## Planning Commission Vote Report

**Subject:** Zoning Map Amendment

**Petition:** **P.Z. 10-2015 Kemp Auto Museum (16955 Chesterfield Airport Rd):**

**PRELIMINARY DEVELOPMENT PLAN**

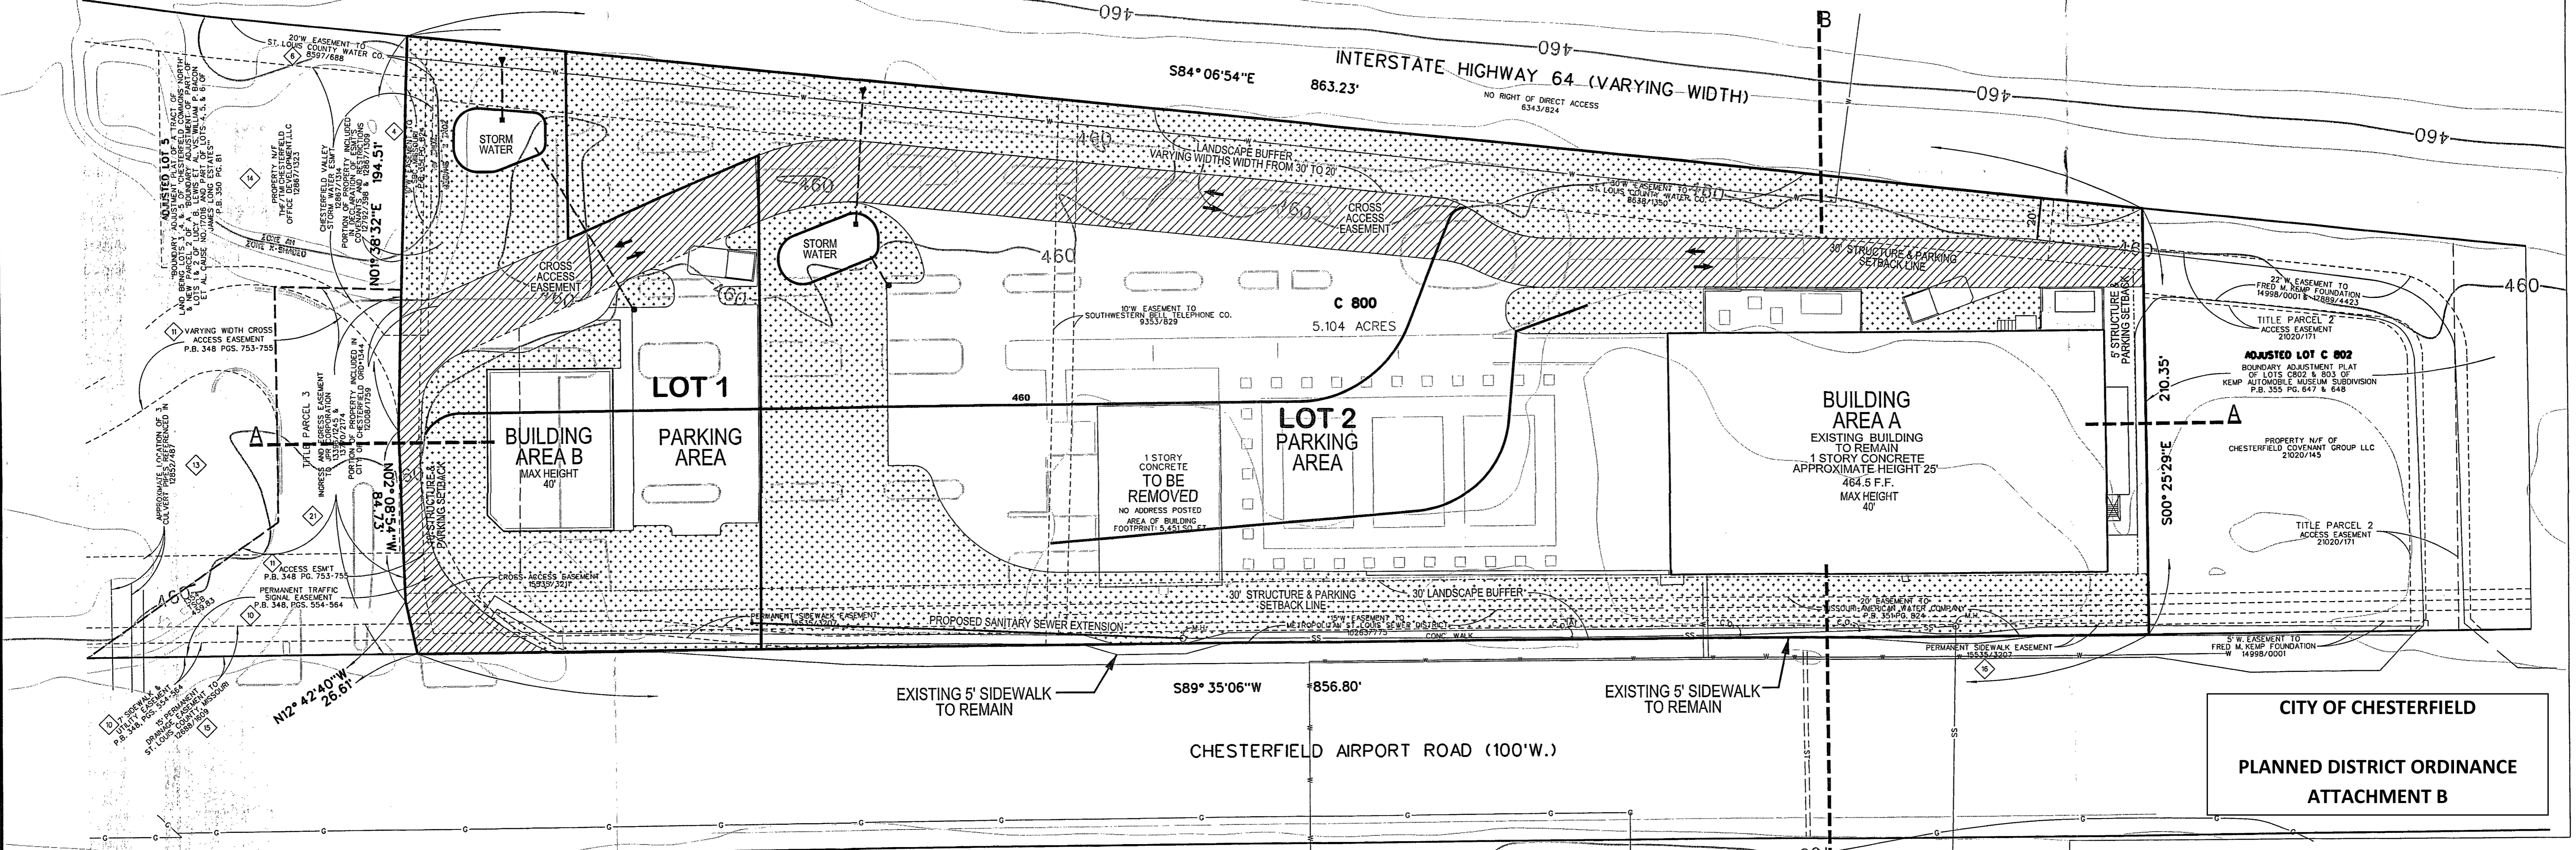
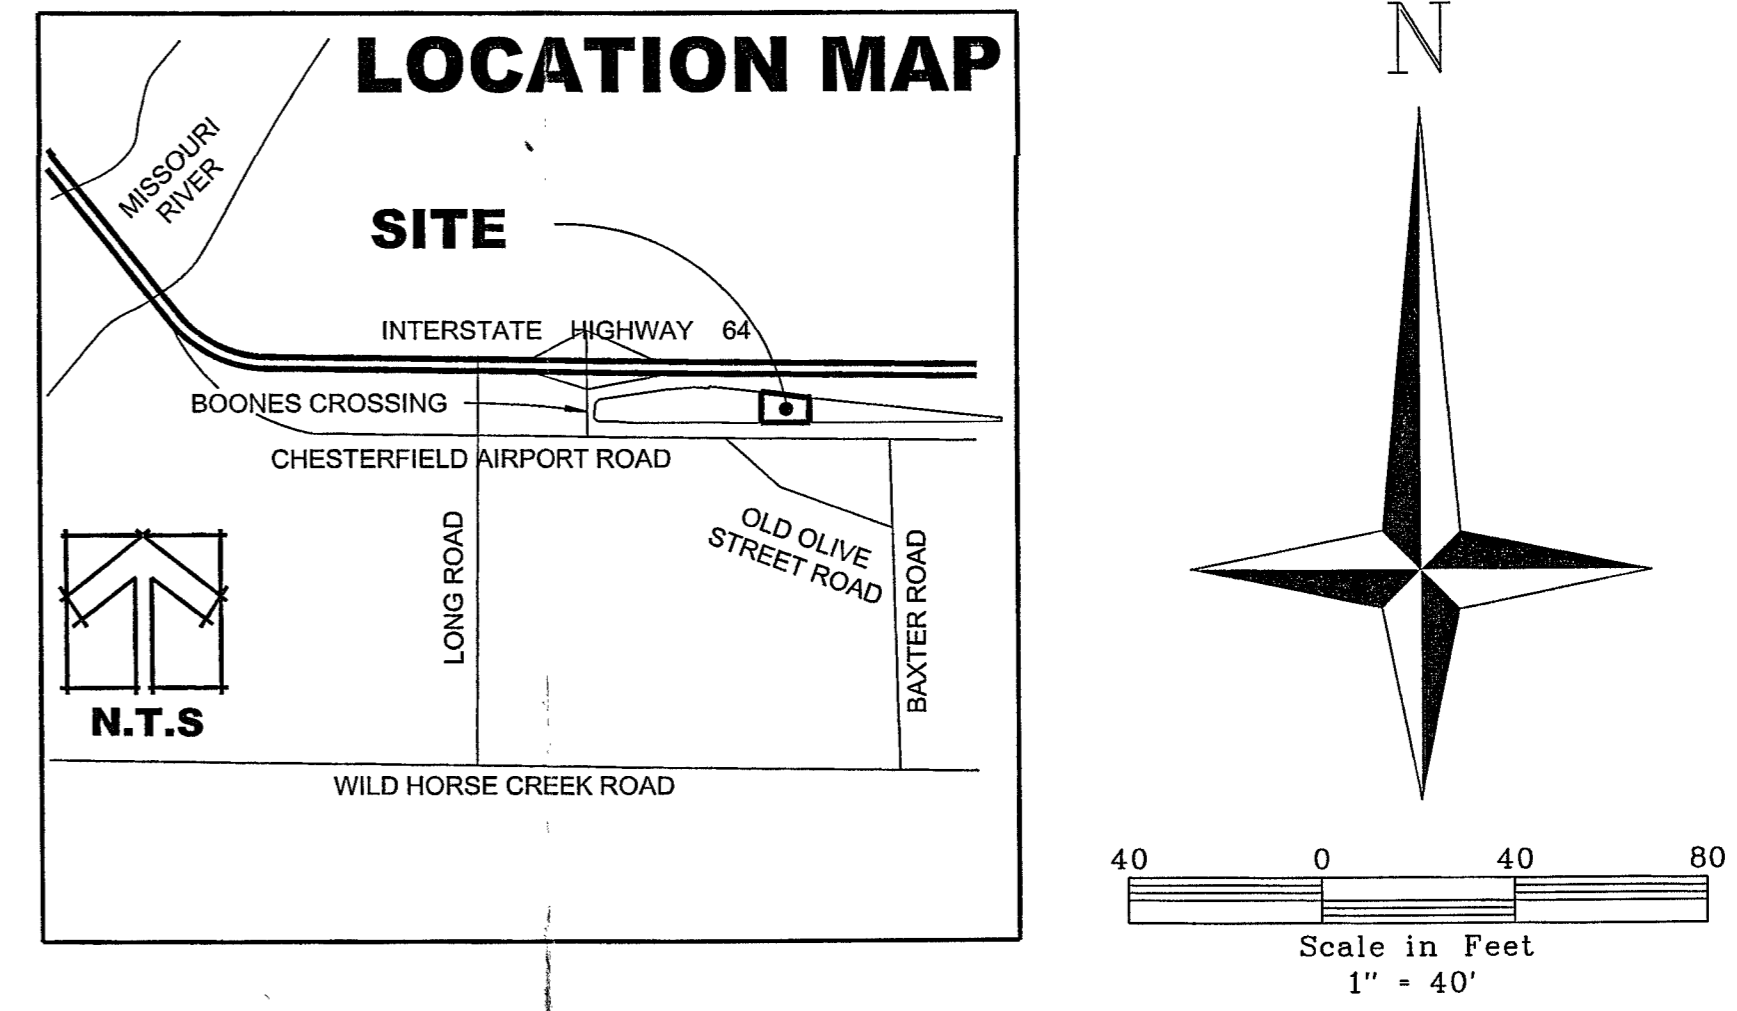
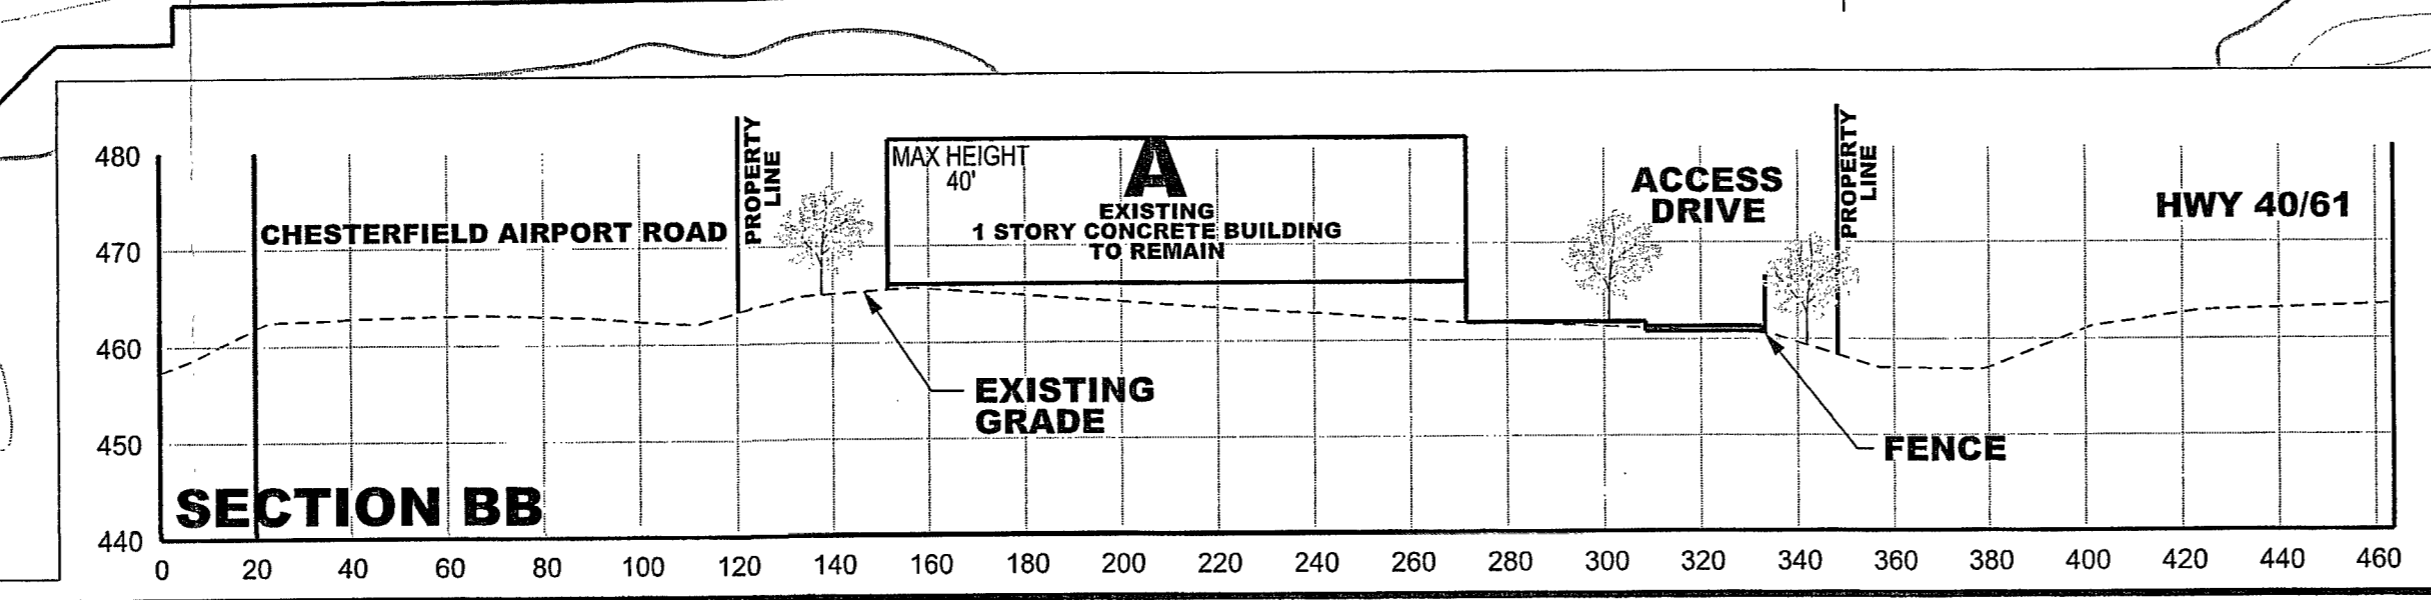
3. List the Open Space on the Preliminary Plan. Be advised, the Unified Development Code requires a minimum of 35% open space for "PC" Planned Commercial Districts.

4. List the Floor Area Ratio (F.A.R.) on the Preliminary Plan. The maximum F.A.R. permitted in the "PC" Planned Commercial District is 0.55.

5. There is some hatching missing around the existing building on the Preliminary Plan. Please amend the plan and provide labels as necessary.

6. Amend the ordinance numbers listed under the existing zoning for the site. The site is governed by both Ordinance 1902 and Ordinance 2116.

7. List the proposed landscape buffers along Hwy 40 and Chesterfield Airport Road in the Project Notes table.

8. Show the proposed side yard setbacks on the plan.

9. Label the sidewalk width along Chesterfield Airport Road. Be advised, a minimum 5 foot sidewalk along Chesterfield Airport Road in conformance with ADA standards will be required.

10. Include a note on the plan referencing the effective FIRM Flood Insurance Rate Maps (FIRM) for the site and show any special flood hazards area on or adjacent to the site.

11. Include a note on the plan that slopes shall not exceed 3 horizontal to 1 vertical.

12. The Preliminary Plan should include the existing and proposed sanitary and storm sewers.

13. Indicate the proposed number of stories for Building Area B on the Section AA and Section BB.

14. During the Public Hearing, Mr. Doster noted that Building Area A, the existing building, may be increased to 3 stories; however the plan shows it as 1 story. Please amend the plan as necessary to show requested maximum building height as well.

15. Be advised, unrestricted cross access is required across this site. Label cross access accordingly and include a note on the plan that cross access easement(s) shall be provided for the adjacent properties as required by the City of Chesterfield and St. Louis County Department of Transportation.

*Response: Revisions made to the Preliminary Plan.*

*Response: Revisions made to the Preliminary Plan.*

*Response: Revisions made to the Preliminary Plan.*

*Response: Revisions made to the Preliminary Plan.*

*Response: Revisions made to the Preliminary Plan. Pursuant to a separate letter, Petitioner has submitted a new request for a variance from the landscape buffer requirements for a portion of the property along Hwy 40.*

*Response: Revisions made to the Preliminary Plan.*

***Response: Revisions made to the Preliminary Plan.***

***Response: Revisions made to the Preliminary Plan.***

***Response: Revisions made to the Preliminary Plan.***

***Response: Revisions made to the Preliminary Plan.***

***Response: Revisions made to the Preliminary Plan.***

***Response: Petitioner does not plan to increase the height of the building and has made requested revisions shown above to the Preliminary Plan.***

***Response: Recorded Access Agreements already exist for both parcels and are noted accordingly on the Preliminary Plan.***
